Interactive comment on “River logjams cause frequent large-scale forest die-off events in Southwestern Amazonia” by Umberto Lombardo

U. Lombardo

Received and published: 25 April 2017

Fig. 1.

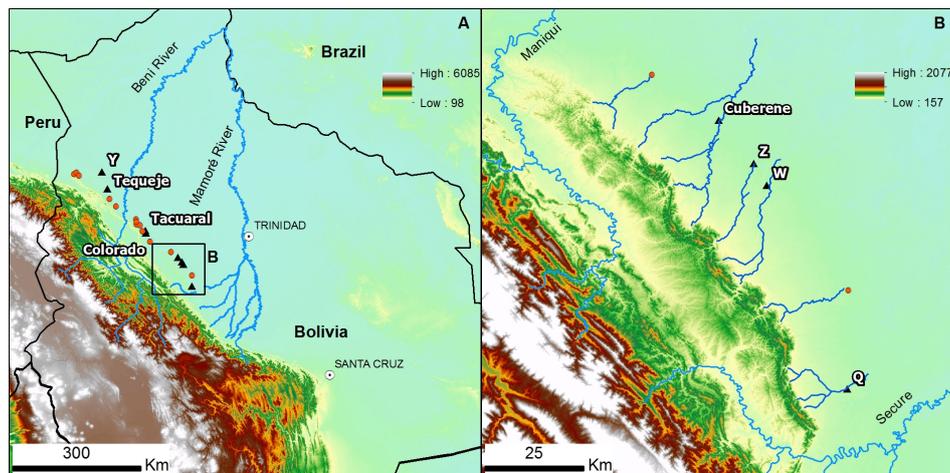
DIXON: Figure 1 – This really needs an elevation scale bar, especially given that a different scale is used for the topography in the two panels. Could also use a map georeferenced/coordinates, either on the edge of the panels, or a spot reference.

REPLY: Elevation scale bars have been added to both panels. As the panel A shows the country borders of Bolivia, Brazil and Peru, I think adding geographic coordinates is not necessary

Fig. 2.

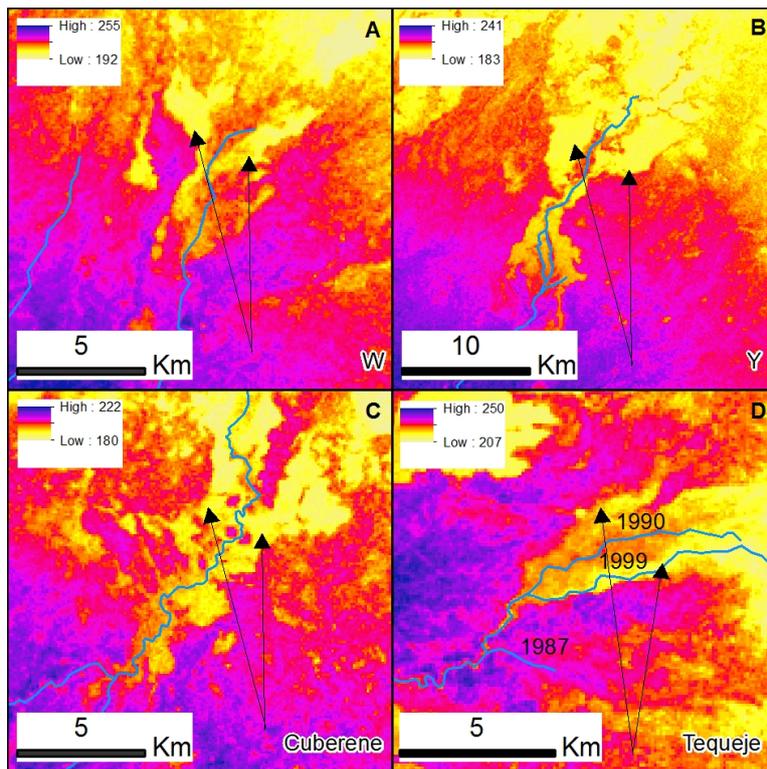
DIXON: Figure 2 – On the inset panels, I know they are all flowing in the same broad direction, but flow direction arrows on the rivers would improve instant clarity.

REPLY: The following has been added to the figure caption: "All rivers flow from southwest to northeast."

Fig. 3.

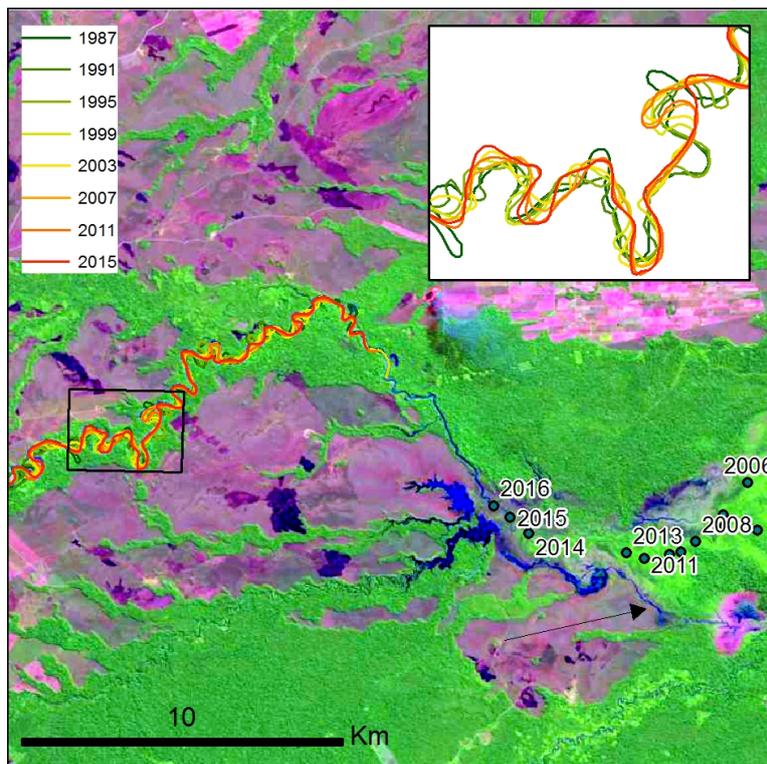
DIXON: Figure 3 – again, flow direction arrow might help

REPLY: The following has been added to the figure caption: "The river flows from southwest to northeast."

Fig. 4.

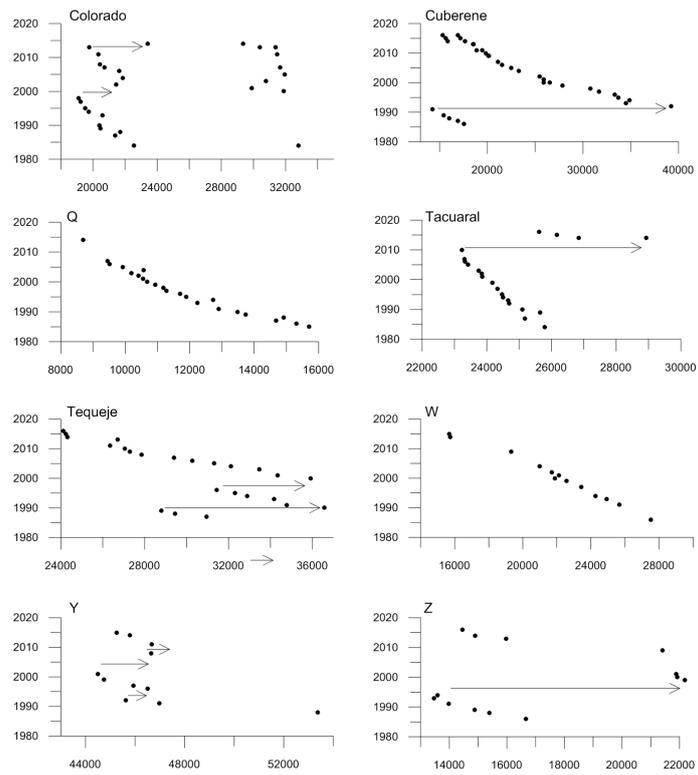
DIXON: Figure 4 – I'm not sure about the colour ramp here! Seems a bit vivid! It's also not quite clear what is going on with the rivers in these images, as the rivers seem discontinuous in places? They appear to be headwaters, but I'm not sure this is actually the case?

REPLY: This is an attempt to use SRTM DEM to actually see the gaps in the forest. As the gaps are visible as small changes in elevation, a vivid colour scale is needed, otherwise the change would not be obvious. The Tequeje river underwent 3 important avulsions, this is why there are 3 different courses in inset D. I have added the years of the 3 courses to make the figure easier to understand.
